Detailed information about proposal, assessment of Clause 4.6 variation request and assessment of departures from controls

1.1. The applicant proposes to demolish the existing structures, remove all trees, subdivide the site in stages, construct new public roads and construct 9 x 4/5 storey residential flat buildings in a staged manner containing 650 apartments and basement car parking, communal open space, landscaping and associated stormwater drainage works and services at 23-27 Schofields Road, Schofields.

Figure 1 Extract of the Applicant's analysis of the setbacks and landscaping to buffer the proposed development from Lot 39 (Source: PBD Architects)

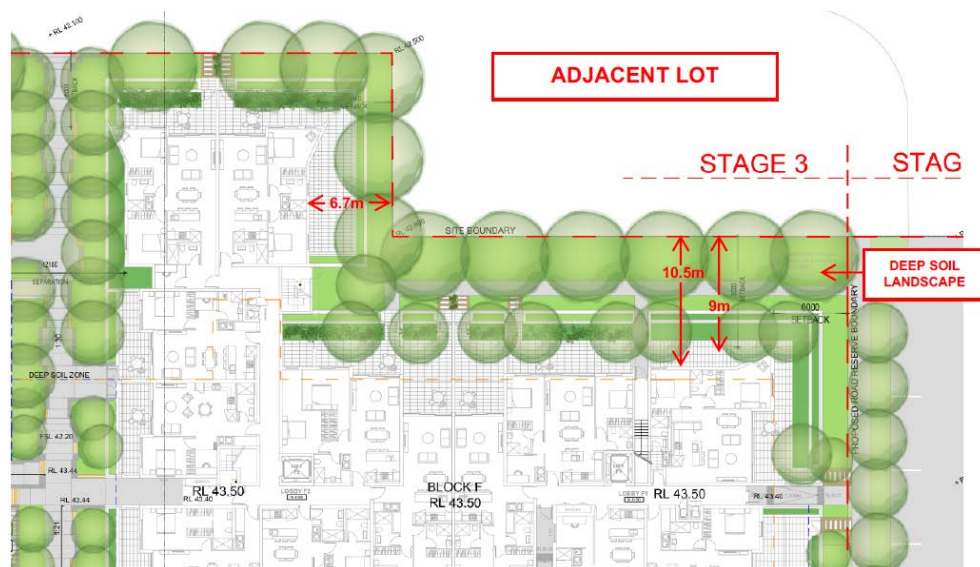
With regard to the adjoining Lot 39 DP 1218200 56 Whitechapel Avenue, Schofields ('Lot 39'), which is in the vicinity of L-Shaped Building F, a setback of 4.5 m to 8 m is provided to the ground level terraces, and a setback of 6.5 m to 9 m is provided for Levels 2 to 5. The proposed setbacks to Lot 39 generally exceed that required by the ADG, which is appropriate given that the development potential of Lot 39 is hampered due to this development, and the Applicant being unable to purchase Lot 39 to be amalgamated with this development site.

The ADG includes a consideration that 'At the boundary between a change in zone from apartment buildings to a lower density area, increase the building setback from the boundary by 3 m' This consideration would result in the building separation between Building F and the boundaries of Lot 39 to be 9 m for the first 4 levels and 12 m for the fifth level.

However, in isolation, it should be considered if merely increasing the building setback from Lot 39 is sufficient to achieve a good development outcome when considering the Precinct and its desired future character and streetscape. Consideration of this impact is provided at **Section 8** of the Assessment Report.

Overall, the non-compliances to building separation are not considered to diminish the amenity of the future residents of the apartments and is considered satisfactory in this instance.

'The development has been designed to provide reasonable privacy and amenity through appropriate building separation and privacy design elements. A setback of 9m to approximately 12 m is proposed between the north façade of Building F and the single lot boundary at all levels. An additional setback at the 5th storey has not been provided as only one unit has the lesser setback of 9 m, the rest of the 5th storey is 9 m from balconies or 10.5 m from a blank wall or bedroom windows which can have louvre screens for increased privacy if required. Louvre privacy screens could also be provided to the balcony at the 5th storey if required.

The separation between the western boundary of the single lot and Building F is 6.7 m to bedroom windows and these can be screened for privacy if required.

To further contribute towards amenity and separation, comprehensive landscaping will be implemented between Building F and the site's northern boundary including medium sized trees to provide an attractive vegetated separation as illustrated below.'

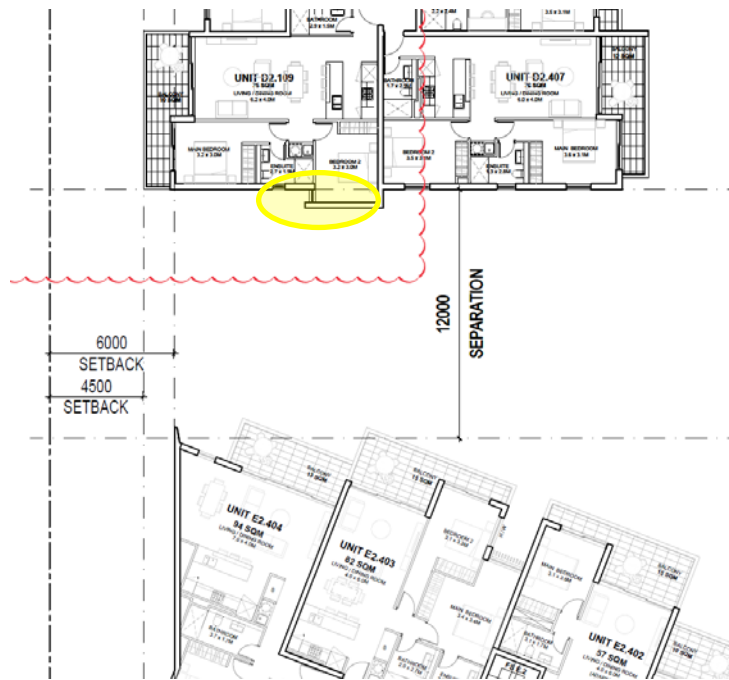
The minimum separation distances are generally satisfied, with the exception of some separation distances being only 10 m as shown on the proposed plans at Attachment 5. An example of this is provided in Figure 2 below:

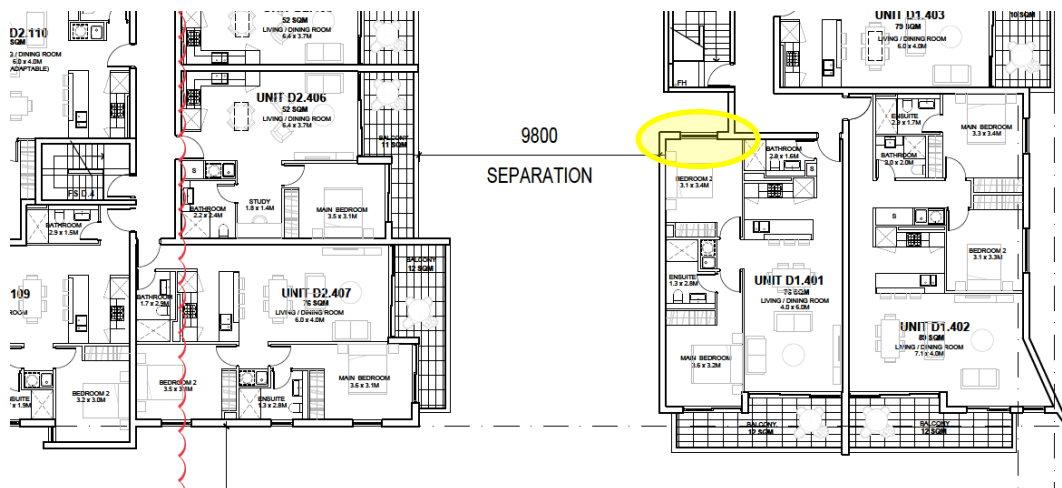
There are also instances of the 12 m building separation not being met by providing a 'blank wall effect' for some units which have the windows to their habitable rooms orientated away from nearby habitable rooms/balconies, as shown in Figure 3 below:

The DCP requires a minimum building separation of 12 m between habitable room / balcony separation distance for buildings 3 storeys and above. Some internal separation distances do not strictly satisfy the 12 m separation distance, for example a separation distance of only 10 m for Buildings D and E.

The Applicant seeks to circumvent this by providing design techniques such as providing blank walls and orientating openings to habitable rooms away from balconies, some of which are suggested by Figure 3F.2 of Section 3F of the ADG.

This approach is considered to result in a poor outcome with regard to building separation and providing a sense of space and amenity for future residents, however no further objection is raised in this instance.

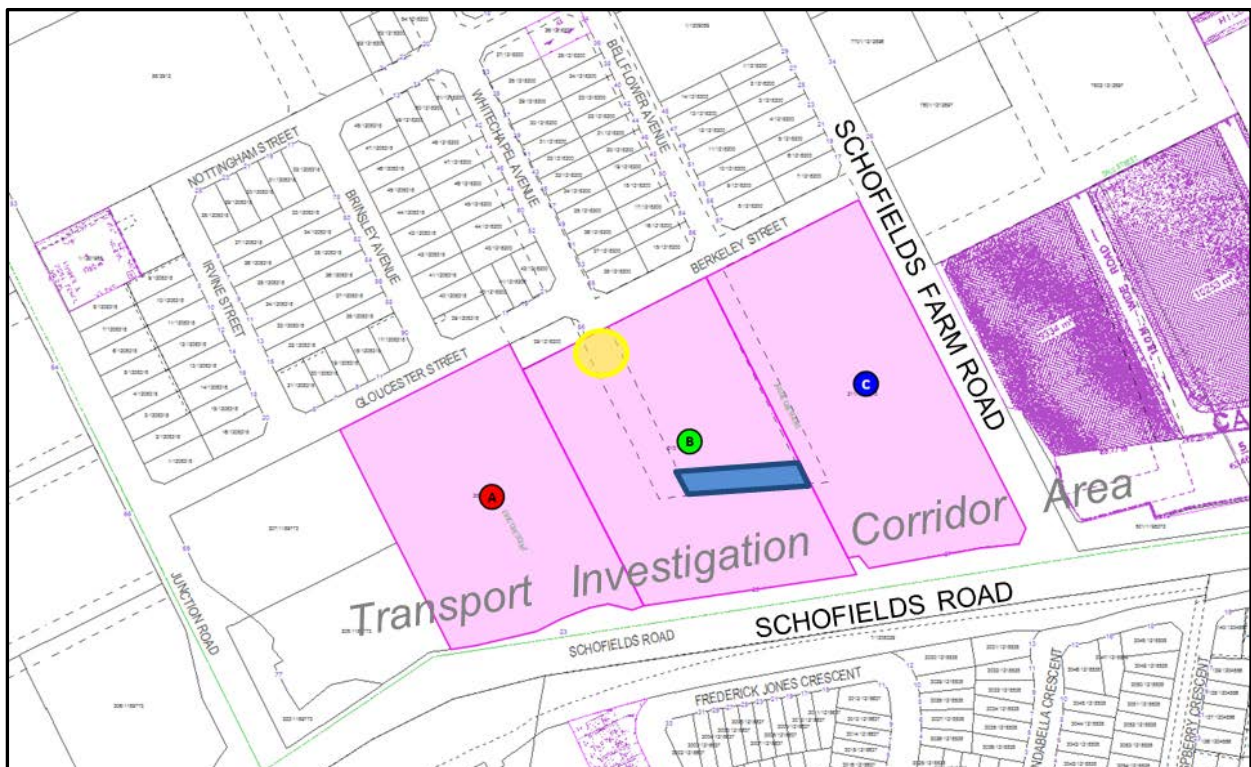
The application seeks to vary the road pattern identified within the Riverstone Precinct Indicative Layout Plan. The variations are identified in Figure 5 below and include:

- The deletion of the new public road connection to Berkeley and Whitechapel Avenue, to be replaced with a cul-de-sac (highlighted in yellow below).
- The addition of an east-west road to create a new connecting road (highlighted in blue below).

- The ILP includes 2 north-south roads within the development site. However, Council's ATMS section does not support the staggered intersection at Gloucester Street, Whitechapel Avenue and Berkeley Street for safety reasons. ATMS recommended a 'peanut shaped' roundabout at this intersection. However, the Applicant has demonstrated that there is

Instead of a roundabout, the Applicant has proposed a cul-de-sac within the development site, with all access via a new public road which connects to Berkeley Street and Bellflower Avenue. This portion of the proposed roads is generally consistent with the ILP. Council's ATMS section does not object to this proposed cul-de-sac arrangement, as it is a safer outcome for motorists and pedestrians.

- The addition of the south-west road along part of the new southern boundary of the site provides a connecting road which ensures that development site is properly serviced by vehicular access.
- The proposed layout is responsive to the imposition of the Transport Investigation Corridor Area along the southern portion of the site.
- With all road pattern variations considered, the proposal developable area is decreased, primarily due to the new east-west road highlighted in blue in Figure 5 above. This is considered acceptable.
